Waterloo Estate (South) – wind assessment report

Further to our recent correspondence, please find herein a brief comparative report detailing the impact of the changes to the Waterloo Estate (South) envelope Masterplan on the expected wind conditions in and around the site. This report follows on from the Arup environmental wind assessment report dated 28 January 2021, and a review of the Hassell Waterloo Estate South, Urban Design review Envelope Approach document dated 21 October 2021.

Figure 1: Summary of test locations and comfort classification

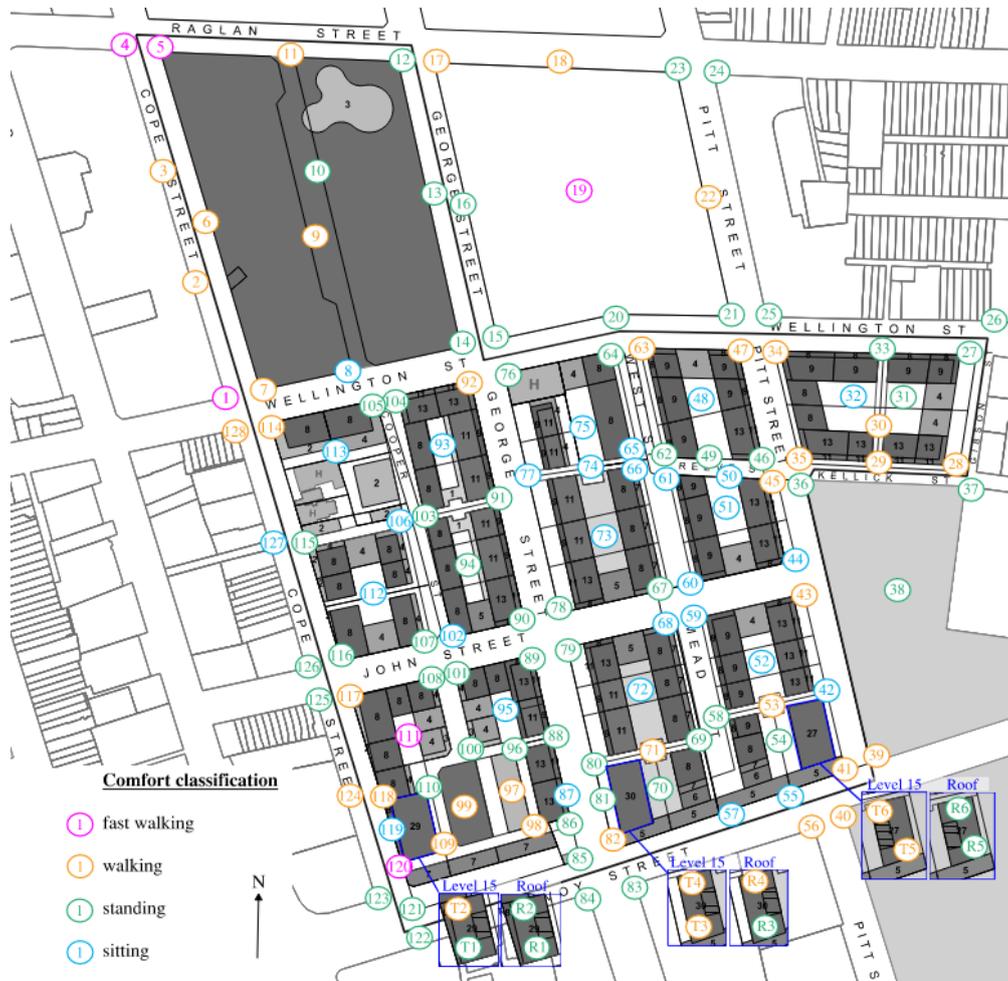
From the previous wind-tunnel testing on a base scheme, the wind conditions on the ground plane at all locations around the site met the safety criterion. Test locations around the outer corners of the entire development, particularly close to the southern towers were close to the safety limit, and caused by the proposed development. The results for comfort classification are reproduced in Figure 1. Locations classified as suitable for walking (orange), or fast walking (pink) approached the safety criterion. The poor wind conditions to the north of Wellington Street were not caused by the Waterloo Estate (South) buildings.

Figure 3: Aerial view looking east of preferred scheme

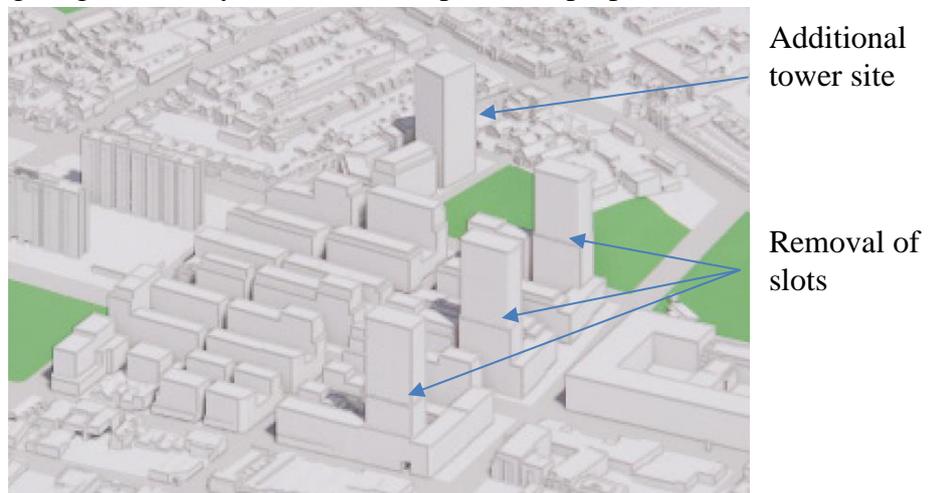
Comparative drawings between the building heights used for the wind-tunnel testing and the current configuration are presented in Figure 2. The tower heights tested in the original wind-tunnel study were lower than the maximum envelope height of RL126.4 m, which are retained in the current scheme. In Figure 2, the primary changes are annotated on the proposed scheme and colour coded with benefit from a wind perspective. It is evident the general orientation, layout, and massing of the development precinct has not changed. The main changes from a wind safety perspective, in order of importance, are:

1. the additional tall tower in the north-east corner,
2. enclosing the laneway from Cope Street in the south-west corner,
3. increase in height of the three southern towers,
4. proposed removal of the mid-height building slots, Figure 3, and
5. the opening of the southern podium along McEvoy Street.

The removal of the mid-height slots and 3-4 storey increase in height to the three southern towers, and the enclosing of the Laneway from Cope Street, would all be expected to increase the wind conditions around the corner of McEvoy and Cope Streets. Without the mature trees in the vicinity of the corner, the wind conditions would be expected to exceed the safety criterion. It is understood that the current design is an envelope, and the final tower volume would be smaller by 10-15%. With appropriate sculpting of the Envelope tower form, it is considered that the safety wind conditions could be achieved, as per the previous testing. The safety wind conditions could be ameliorated with altering the building massing for example by rounding the south-west corner, increasing the tower setback from the podium edge to the west, reducing the height of the tower, introducing appropriate place articulation, and incorporating an awning structure around the corner. Some generic information to improve the wind conditions around an isolated tall building is provided in Figure 4.

The preferred location of the additional tower on Kellick Street to the north-east of the site, Figure 2, is not ideally located from a wind perspective. A tall building in this elevated location is exposed to all prevailing strong wind directions. The wind conditions at Location 28, on the corner of Kellick and Gibson Streets, Figure 1, approached the safety criterion. With the significant increase in building massing, this and nearby locations along Gibson and Kellick Streets, and Waterloo Park would be expected to exceed the safety criterion. The ground level wind conditions would improve significantly if the tower were moved to the west away from the corners of the block. The tower location allows the retention of three mature trees on the corner of Kellick and Gibson Streets, which will improve the wind conditions around this corner, but as not permanent should not be relied on to mitigate safety conditions. If this is not possible to move the tower for other design

requirements, the amelioration techniques through shaping of the tower, as discussed above and in Figure 4, should be used to improve the wind conditions. The wind conditions around this isolated tall tower will require significant consideration of the building geometry to improve the wind conditions to a safe level
